TRIOMATIC COUPLINGS WITH IMPROVED DESIGN

With a new **TrioMatic** design we have responded to the stringent requirement of customers to differentiate the **WABCO TrioMatic** coupling from copy or fake parts.

IMPROVEMENTS

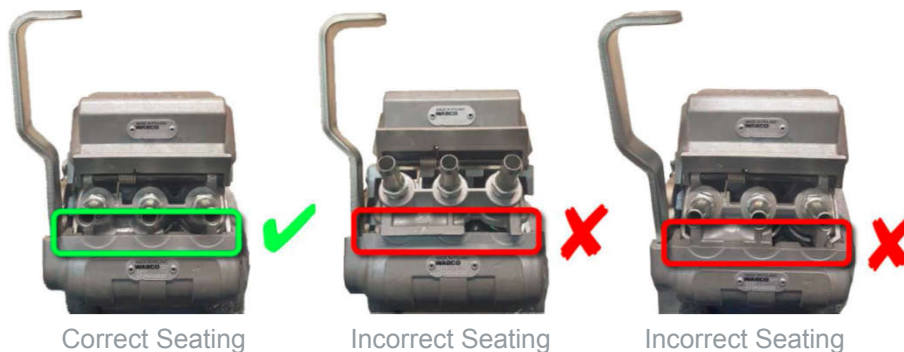
Male part coupling forehead is machined to provide better sealing

- Using a different casting method made the parts lighter while maintaining corrosion resistance and strict tolerances
- The look of the part has been improved by implementing the **WABCO** corporate design
